July 3, 2013

Re: Preliminary FEMA Map Appeal – Weber Park Pond/Morningside Area; City of Edina, MN

Weber Park Pond/Morningside Area Preliminary Zone A (panel 362F)

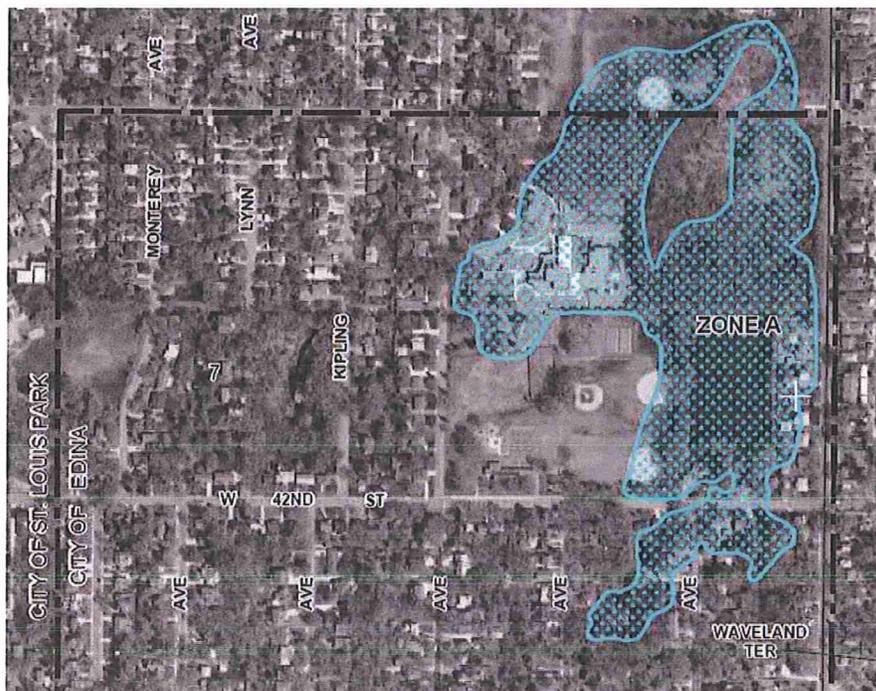
The Weber Park Pond/Morningside area of Edina has been identified by FEMA as a Zone A with no base flood elevation determined. The extent of the 100-year floodplain area shown on the Revised Preliminary Hennepin County Flood Insurance Rate Map (FIRM) dated August 17, 2012 (panel 362F) extends beyond the flood inundation area that corresponds to the 100-year flood elevation of 869 feet MSL (NGVD29) identified in the City of Edina's December 2011 Comprehensive Water Resources Management Plan (CWRMP).

The City is submitting this correspondence and supporting documentation to appeal the proposed floodplain area around Weber Park Pond because it is technically incorrect due to insufficient and out-of-date data. According to the Revised Preliminary Hennepin County Flood Insurance Study (FIS) dated August 17, 2012, the hydrologic and hydraulic analyses used to create the proposed floodplain area around Weber Pond were performed by the USGS in April 1978 and has not been updated since that time. The following information is provided “to demonstrate that alternative methods or applications results in more correct estimates of base flood elevations” (*Title 44, Chapter I, Part 67 of the Code of Federal Regulations, §67.6*).

In 2003, detailed XP-SWMM hydrologic and hydraulic models were developed for the entire city of Edina. In 2006, revisions were made to the XP-SWMM model in the Morningside area to reflect more accurate and up-to-date information. The revisions incorporated updated topographic information for both the City of Edina and the City of St. Louis Park. The model was also updated to include several St. Louis Park watersheds that drain into the City of Edina’s system in this area. Modeling results indicate a 100-year flood level in Weber Park Pond of 869.0 (NGVD29). The ponding area south of West 42nd Street between Alden Drive and Scott Terrace, connected to Weber Park Pond by storm sewer, has a 100-year flood elevation of 869.2. The ponding area south of West 42nd Street between Scott Terrace and France Avenue, connected to Weber Park Pond by storm sewer, has a 100-year flood elevation of 869.4.

The City proposes that the FEMA floodplain map be revised to reflect the results of the more detailed modeling and mapping information described above.
